Re: Re-zoning and Development Permit Application: 1400 Fairfield Road and 349/351 Kipling Street

Appendix A: Summary of Plan Revisions

Re: REZ No. 00702 & DP No. 000555 (1400 Fairfield Rd. and 349 Kipling St.)

Figure 2: Approved Designs & Recent Construction near 1400 Fairfield Rd. 349 Kipling St.

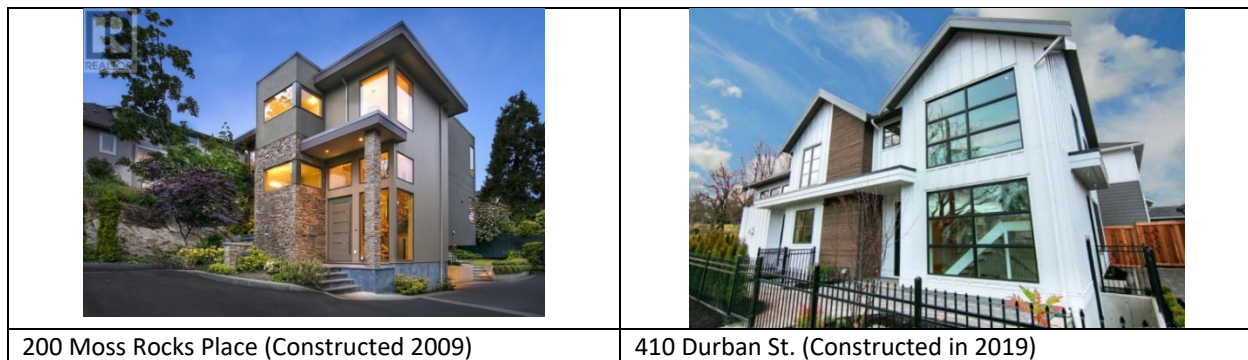
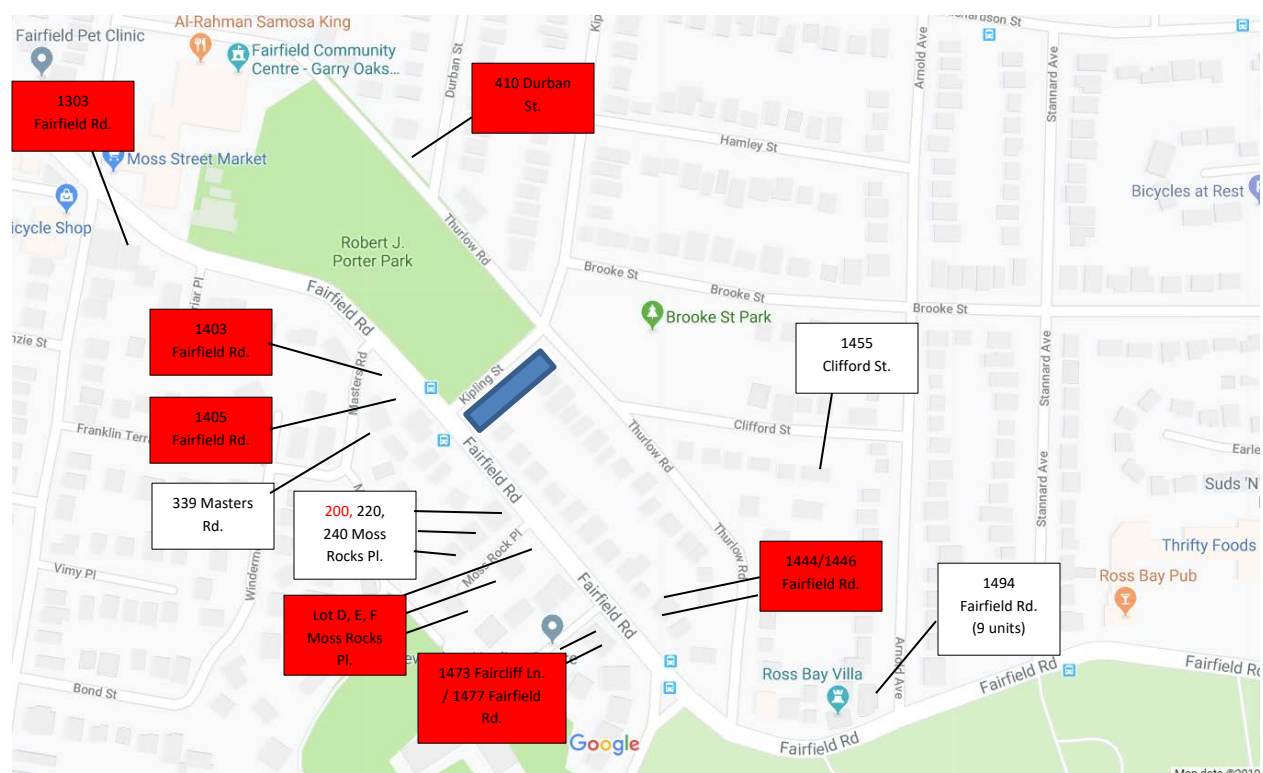
Condition #5: *“The guidelines encourage a contextual architectural response to consider and incorporates design features that compliment the form and character of the area. The proposed design lacks consistency with this direction. Please consider a design that better reflects the predominant form and character of the area.”*

- **Applicant Response / Actions Taken:** Contemporary designed residences are becoming increasingly common in this part of the Fairfield neighbourhood. The majority of residences that have been recently constructed near the proposed development site, or are proposed to be built near the proposed development site, are of contemporary or transitional designs. The contemporary design of this project proposal is intended to respond to new construction which has been emergent in the Fairfield neighbourhood. **Figure 2** provides illustration of nearby residences, which have been recently constructed, or designs, which are approved for

construction. **Figure 3** illustrates locations of these residences relative to the proposed development site.
